[Docket No. 96-CE-09-AD]

Airworthiness Directives; The New Piper Aircraft, Inc. PA-24, PA-28R, PA-30, PA-32R, PA-34, and PA-39 Series Airplanes

ACTION: Notice of proposed rulemaking (NPRM).

Figure 1

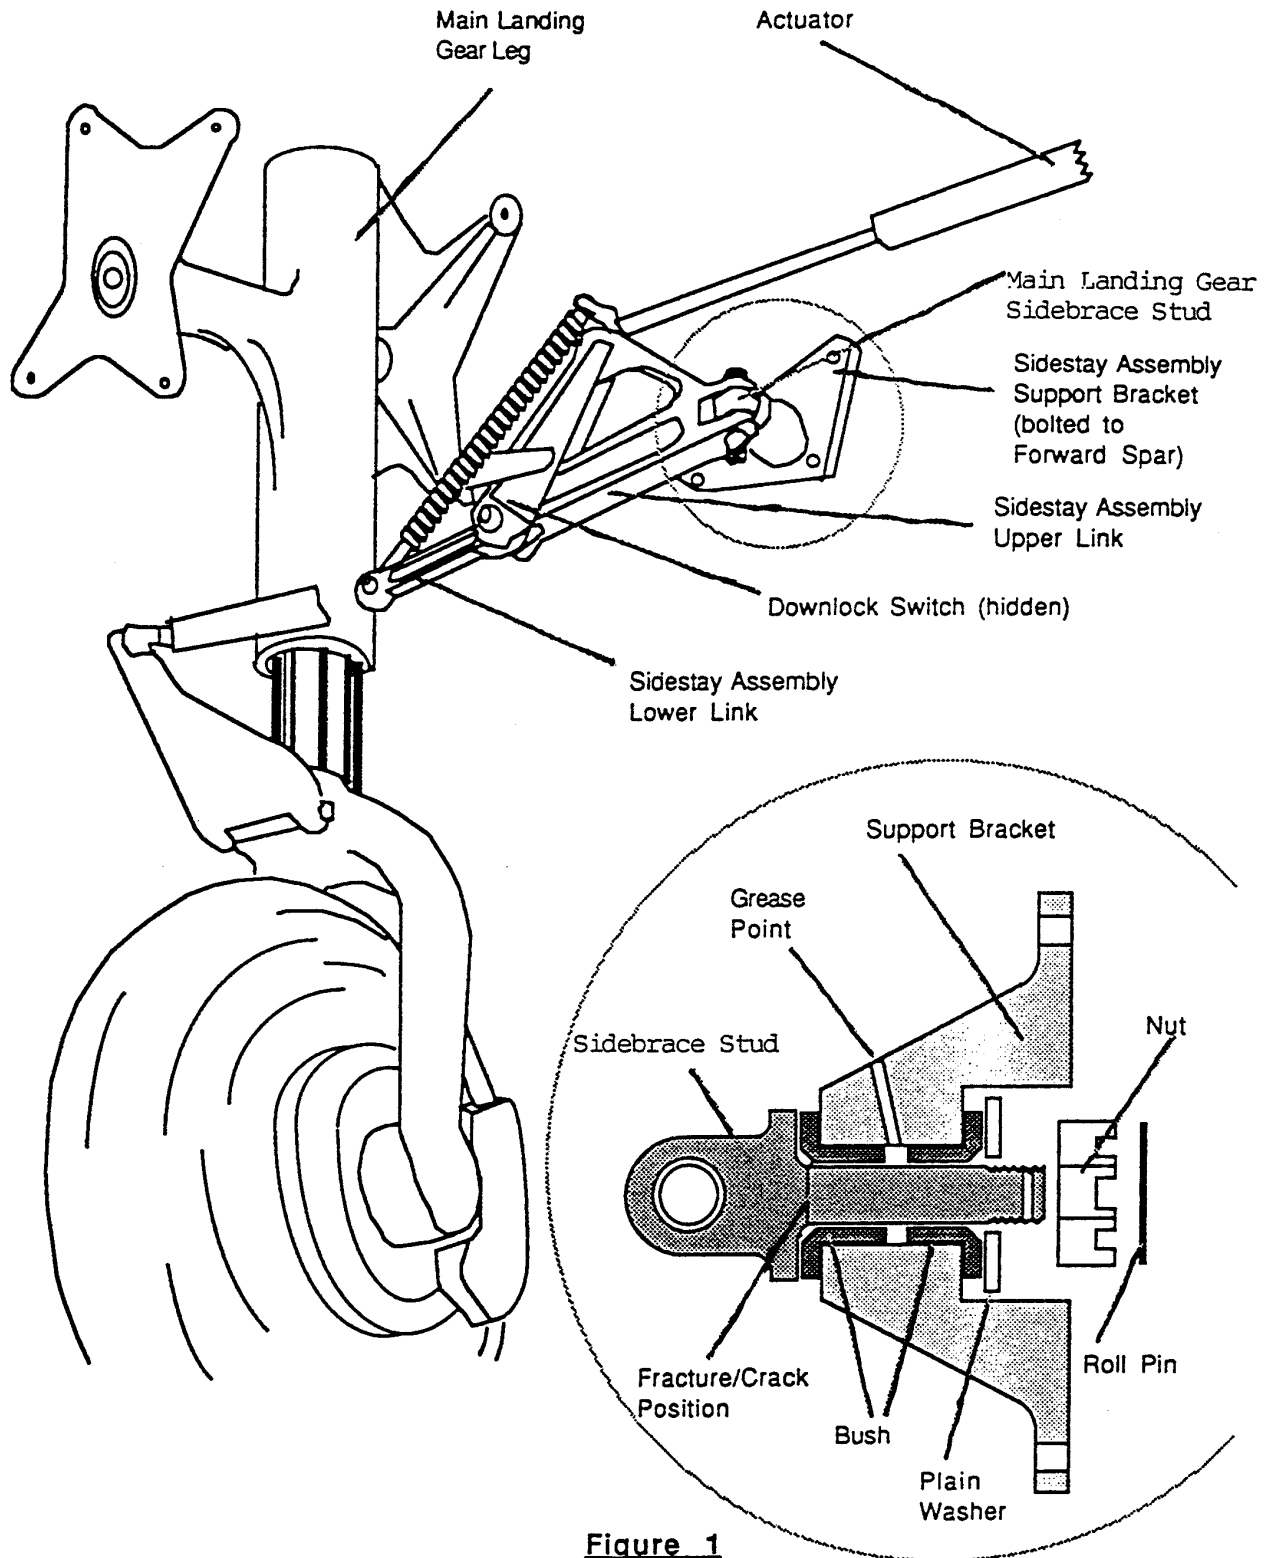
(a) Remove both the left and right main gear sidebrace studs from the airplane in accordance with the instructions contained in the Landing Gear section of the maintenance manual, and inspect each main gear sidebrace stud for cracks, using Type I (fluorescent) liquid penetrant or magnetic particle inspection methods. Figure 1 of this AD depicts the area of the sidebrace stud shank where the sidebrace stud is to be inspected.

Note: This figure is provided to depict the area of the sidebrace stud to be inspected. This is not intended to represent the configuration of all models affected.
